DEVELOPMENT REVIEW BOARD
SUPPLEMENTAL SUBMITTAL

PROJECT NO. 2020-003461 (17EPC-40043)
Application No. SI-2020-00052

SUBMITTAL DESCRIPTION: Revised plans, Approved Fire One, and response to comments

RE: Project #2020-003461/SI-2020-00052 (17EPC-40043), Taylor Ranch Housing
Site Plan-EPC Major Amendment

LIGHT STANDARD

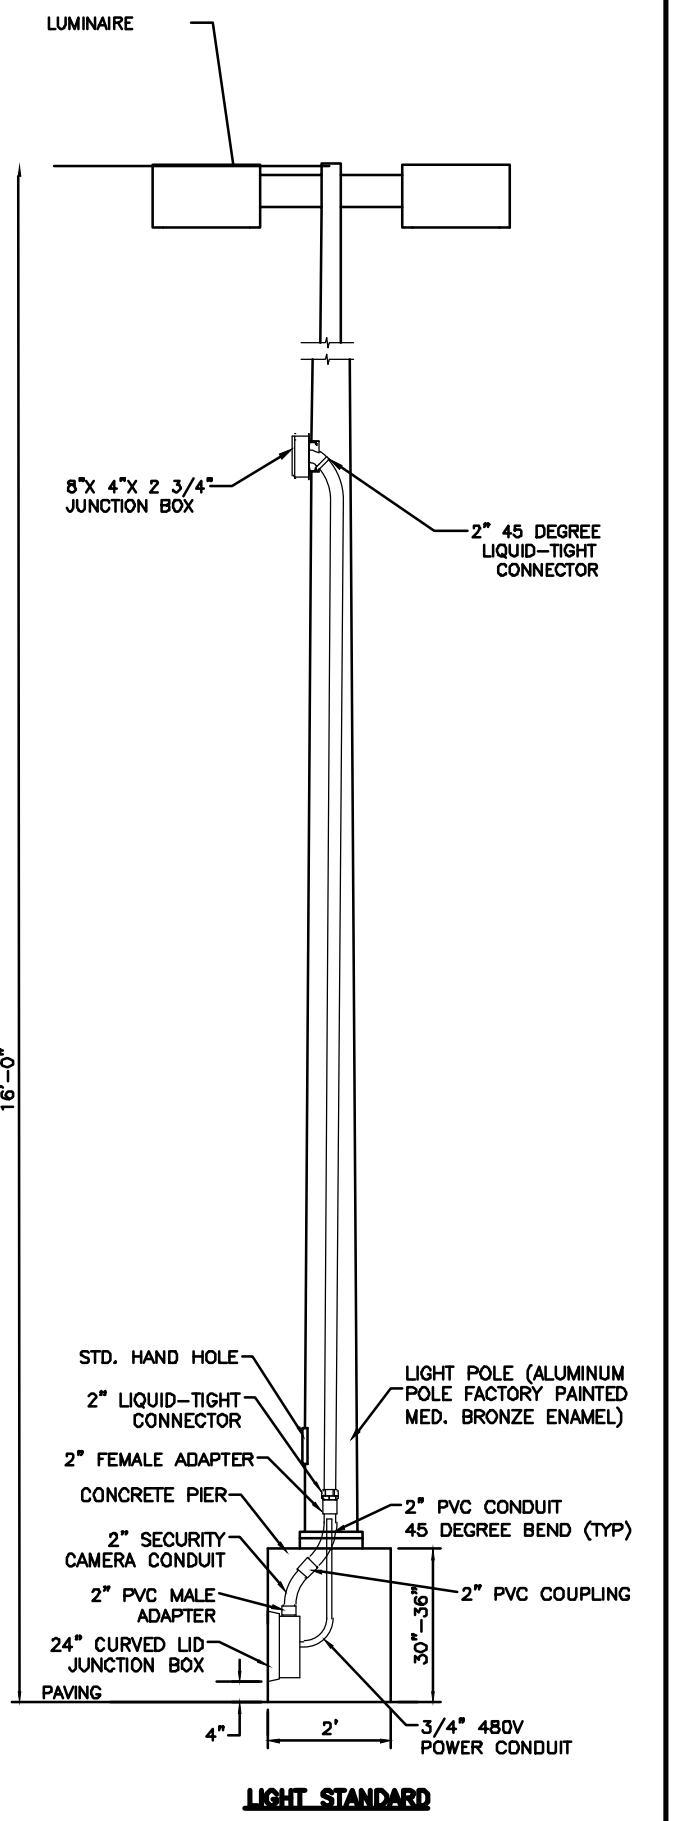
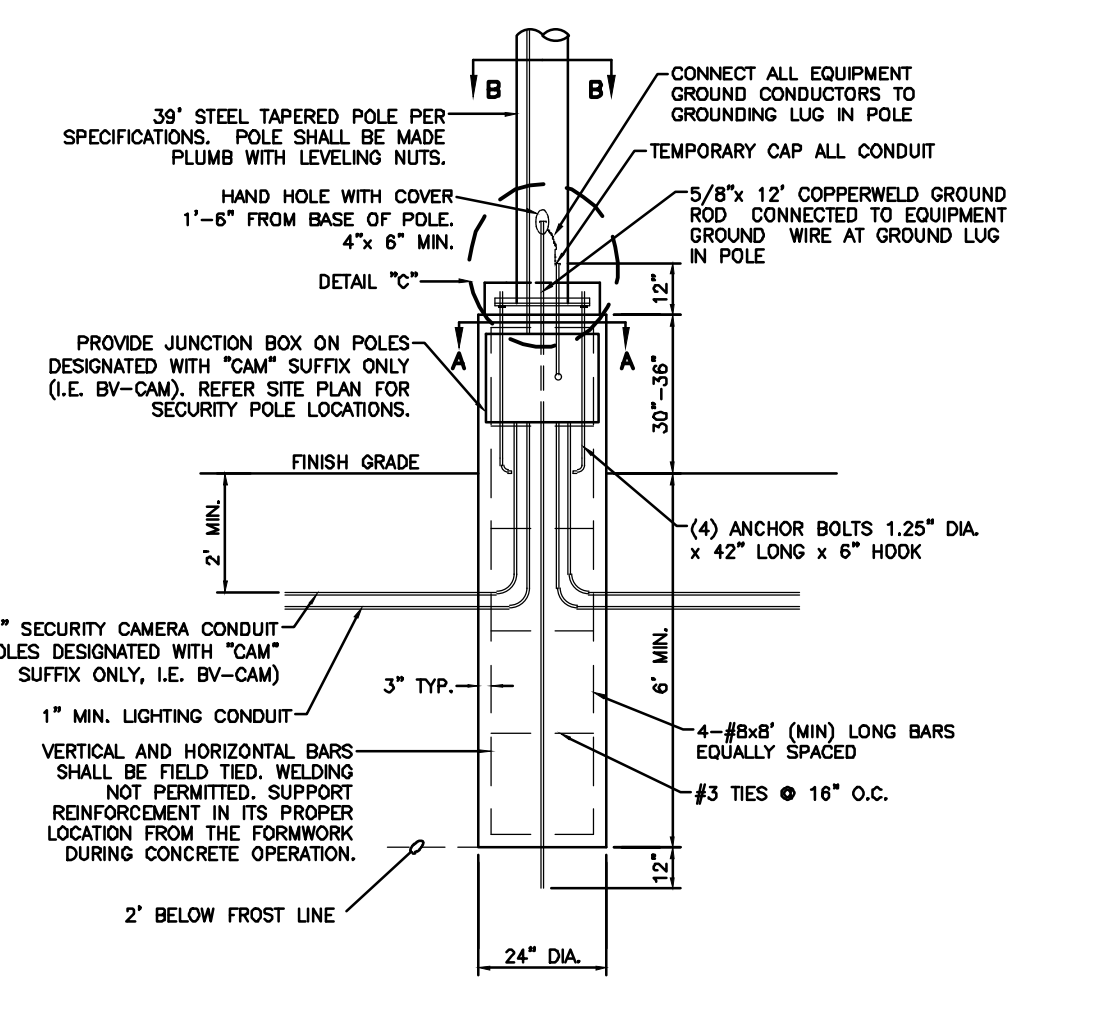
10. Condition 9A- unmet: A standard light pole detail was not provided. The detail on Sheet C5 is only for lights with "pole mounted cameras", which are not referenced on the main site plan. This detail should be removed.

Note: the top height of this light pole is not dimensioned or scaled, but clearly exceeds the allowable height of 20 feet.

Response: Detailed updated.

PARALLEL CURB HC RAMP
NOT TO SCALE

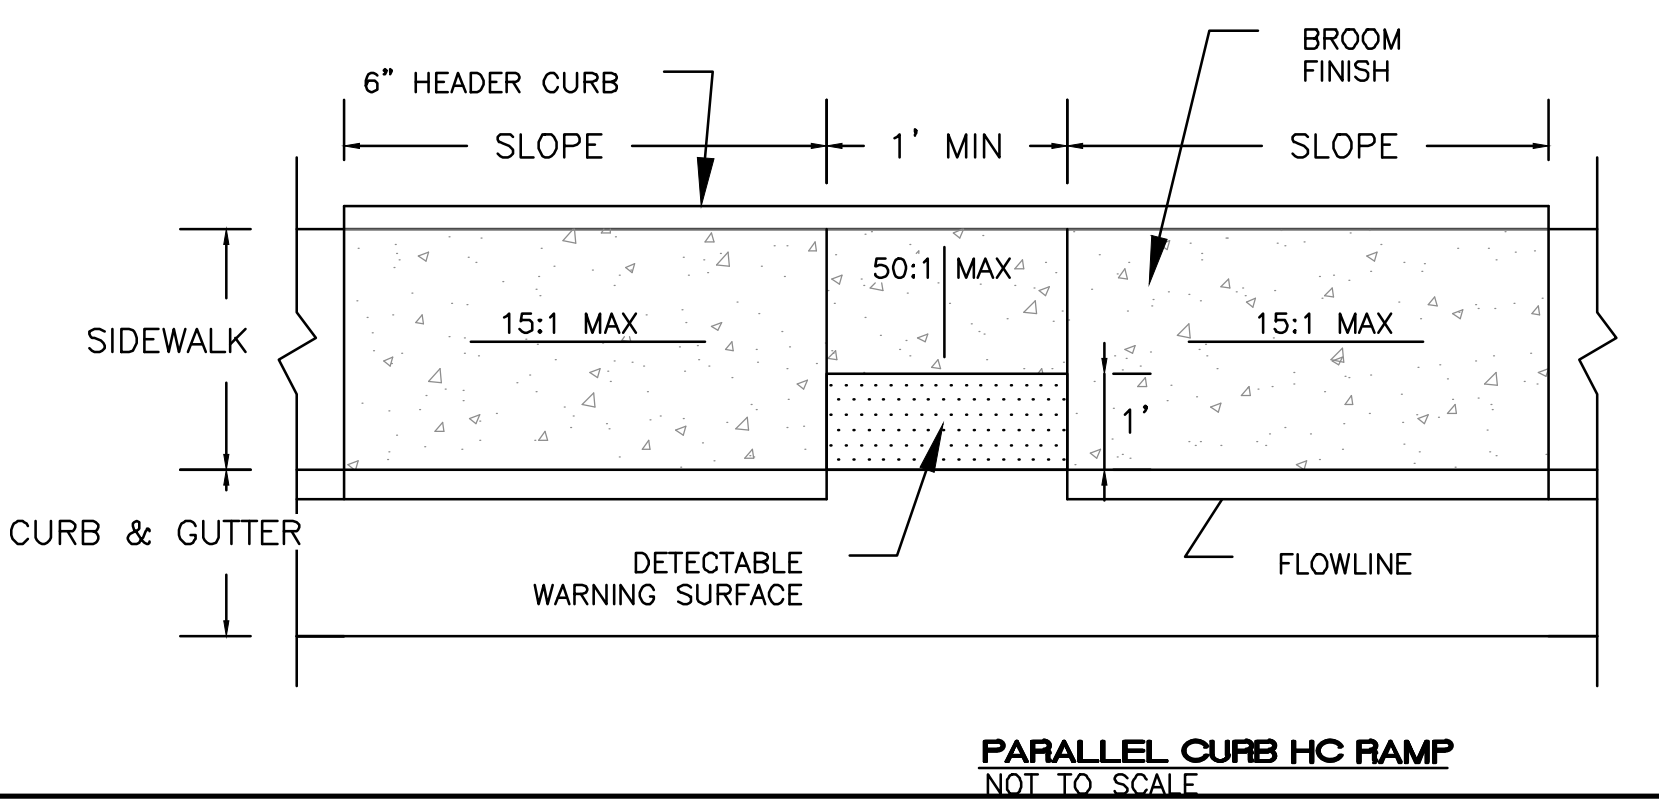
9. Show both types of curb ramp details called out on the plan. One is uni-directional; the other is a parallel curb ramp in front of the accessory buildings.

Response: Added detail to C-5.
